**Re: Lester Residence, 839 Shire SW, Grading and Drainage Plan
Engineer's Stamp Date 10-06-11 (L08/D001)**

SUBJECT: Lester Residence L08/D001

**Re: Lester Residence, 839 Shire SW, Grading and Drainage Plan
Engineer's Stamp Date 9-2-11 (L08/D001)**

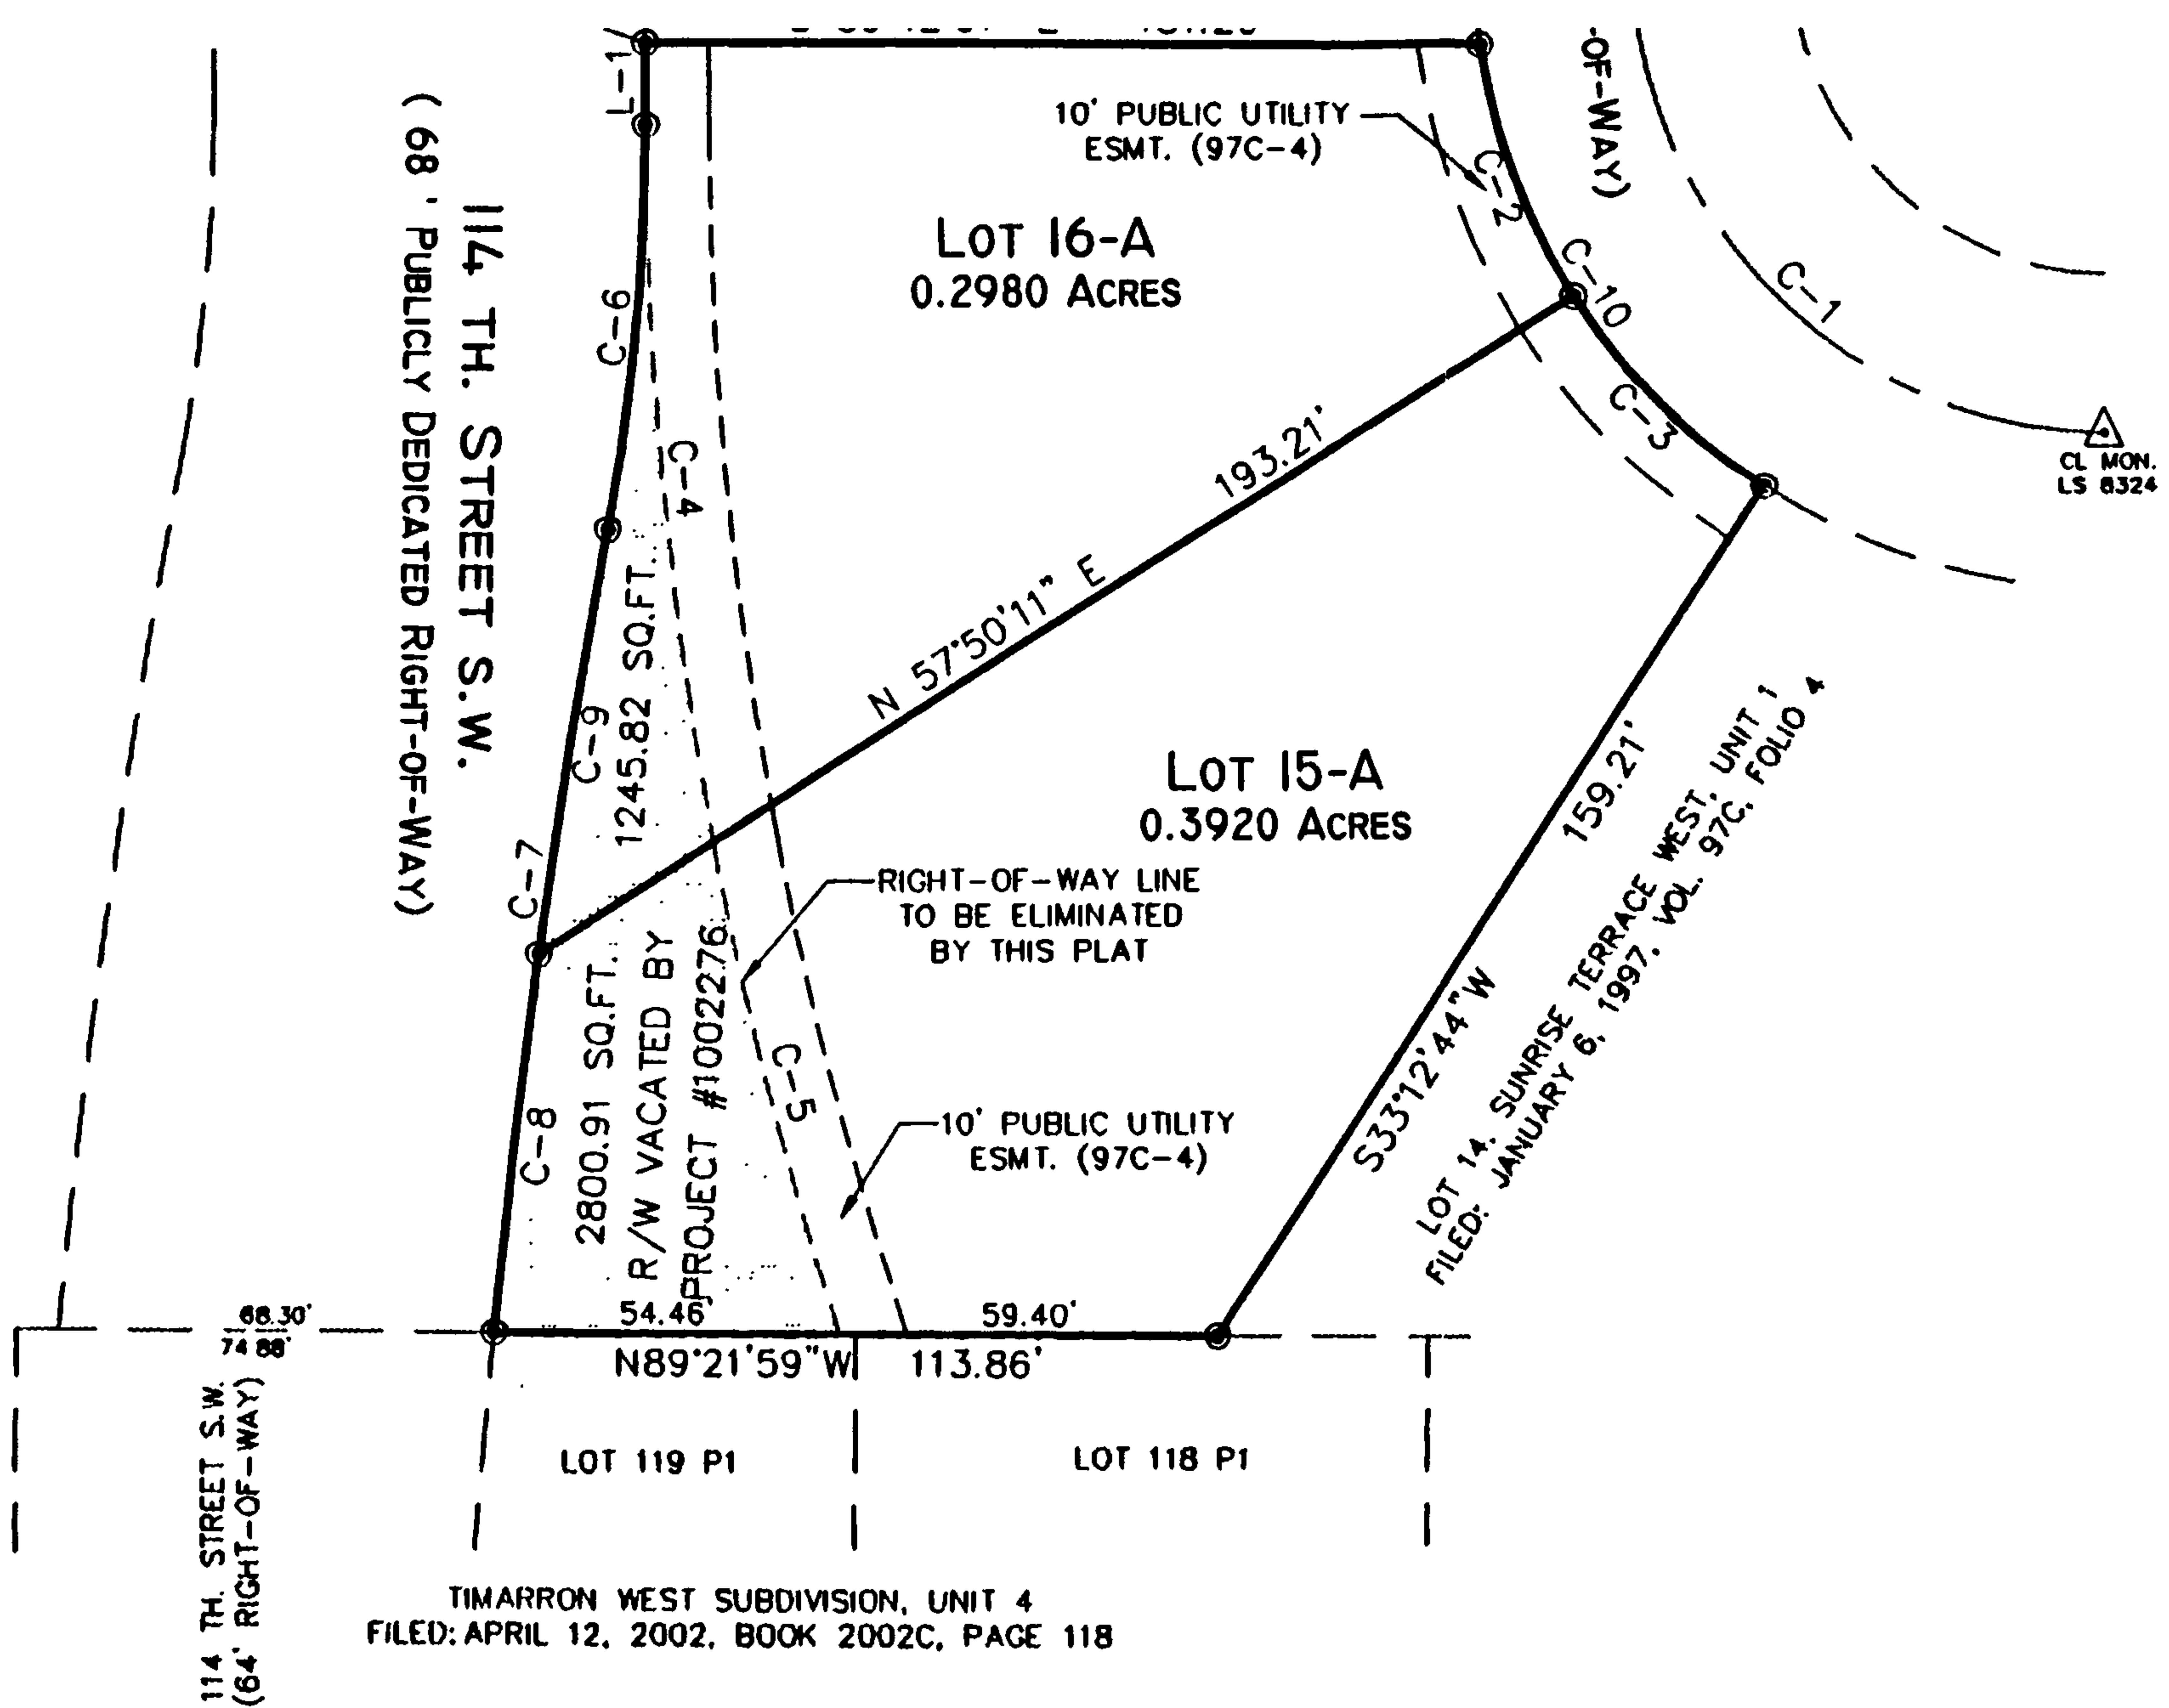
- No access is allowed from 114th Street, SW.
- The proposed gazebo on top of the existing PUE has to be moved outside the easement.
- Please verify the location of the exiting PUE. The existing PUE does not appear to be shown in the correct location.
- Some blocks has to be turned for drainage along the 114th street. Place the bottom of the block opening a minimum of 4" above finished grade. Also place a filter fabric at the opening.

1. The 114th Street access is by an existing gate that has been utilized by the property owner for quite some time. This Plan does not attempt to change that condition. I recommend this be deferred to Zoning and Traffic, and not remain a drainage issue.
2. The existing 10' PUE is not connected to public right-of-way due to a previous vacation action that allowed the owner to claim excess right-of-way. The position of the PUE has been corrected per the recorded plat, which eliminates the encroachment by the proposed gazebo. The existing sundeck is now located within the easement, however, the sundeck is a wooden structure that is not considered an encroachment by the dry utility providers.
3. As we discussed, all drainage flows east, away from 114th Street, therefore, drainage improvements are not necessary at the existing block wall.
